Post Public Consultation Report

Transport Infrastructure Ireland

5207356DG966

N4 JUNCTION 4 FOOTPATH - CYCLEWAY

Figure 3-1 - Indicative Sketch of preferred option

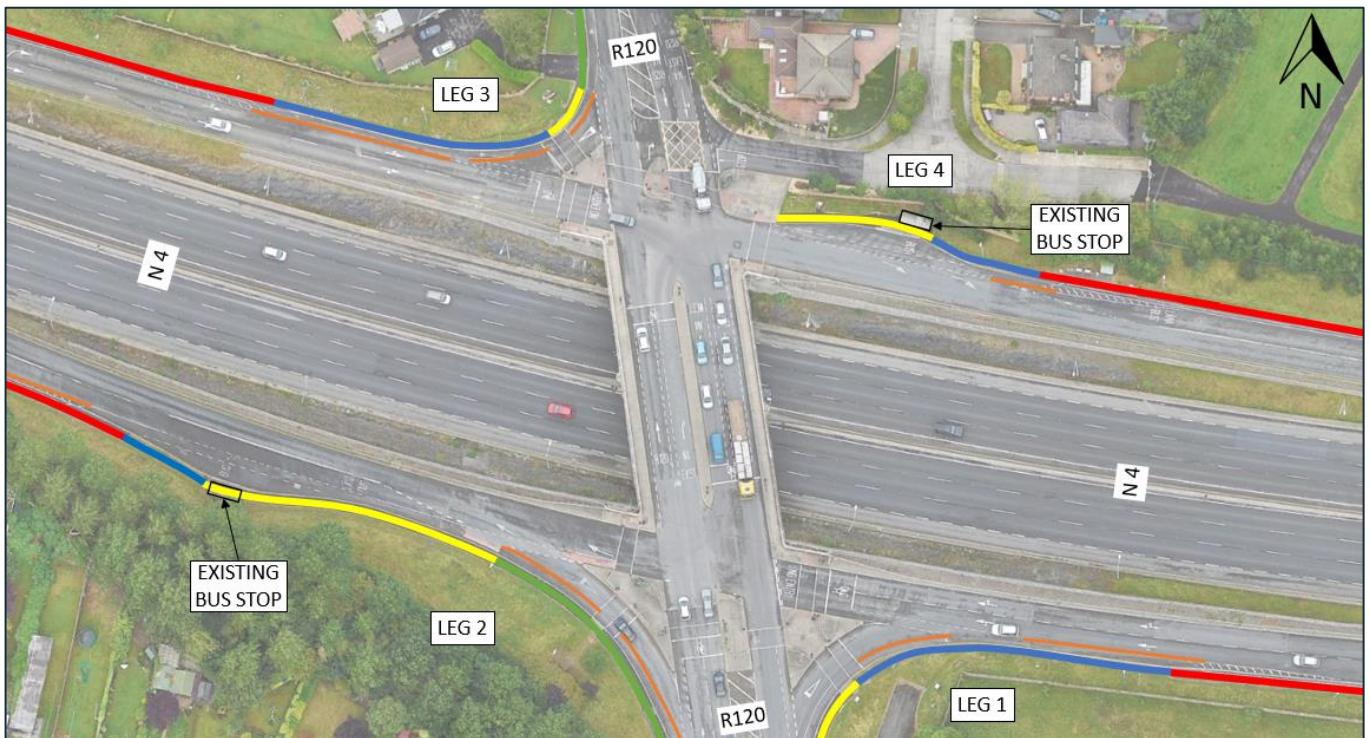
Issue	Description	Count	Percentage of responses	Response
<p>Safety enhancement and optimisation of available space along the junction legs.</p>	<p><i>“1 - There is room along the inside of the existing footpath for the footpath and red cycleway to be moved inwards, opening up this junction and allowing more room for the turning of vehicles. It is a waste not to use the land available to open up this junction which will improve sight lines for all and make the turn safer.</i></p> <p><i>2 - Please remove the plastic bollard obstacles which intimidate cyclists and physically make it harder to manoeuvre, for example overtaking another cyclist (apart from the bad use of more plastic and concrete which harms the environment!)</i></p> <p><i>3 - We need to widen all roads where possible and absolutely stop reducing them. Buses, emergency vehicles, trucks, coaches, removal trucks and delivery vans have to be accounted for and given space to manoeuvre.</i></p> <p><i>4 - Moving signage is easy to do when moving pathways ‘inland’. Many of these areas should have shared pathways/ cycle lanes as there will never be the usage that some people think there will be as there is no reason to walk in many of these areas as they do not link houses or shops/utility areas.”</i></p>	<p>1</p>	<p>100%</p>	<p>1. Appropriate vehicle tracking will be completed at detail design stage to allow sufficient turning space for vehicles making use of the junction. Improvements to the safety and sightlines of the junctions will be considered during the detail design stage.</p> <p>2. The bollards are proposed to enhance cyclist safety by creating physical separation from general vehicles, particularly at junctions where the risk of conflict with vehicles is higher. Suitable bollards for cycle lanes will be specified at detail design stage so as to not restrict cyclist manoeuvres.</p> <p>3. As per point 1 above, all appropriate vehicle tracking will be completed at detail design stage to allow sufficient turning space for all vehicles making use of the junction.</p> <p>4. Existing pedestrian desire lines indicates foot traffic on the existing grassed areas, as such segregated cycle lanes will minimise the risk of conflict between pedestrians and cyclists.</p>

The comments and suggestions received regarding the N4 Junction 4 Lucan Footpath-Cycle scheme highlighted several key points. One suggestion was to move the footpath and cycleway inwards to improve vehicle turning space and sightlines. In response, it was noted that vehicle tracking will be completed at the detail design stage to ensure sufficient turning space and improved safety and sightlines. Another comment requested the removal of plastic bollards, which were seen as intimidating to cyclists and environmentally harmful. The response clarified that bollards are intended to enhance cyclist safety by separating them from vehicles, especially at junctions with a risk of accidents occurring, and that suitable bollards will be specified to avoid restricting cyclist manoeuvres.

The proposed changes raised by members of the public have been noted in this report. There are no changes made to the proposed design after reviewing the additional changes proposed by the public through the South Dublin County Council's Public Consultation Portal however the detail design will account for the request with respect to vehicle tracking and selection of an appropriate bollard type.
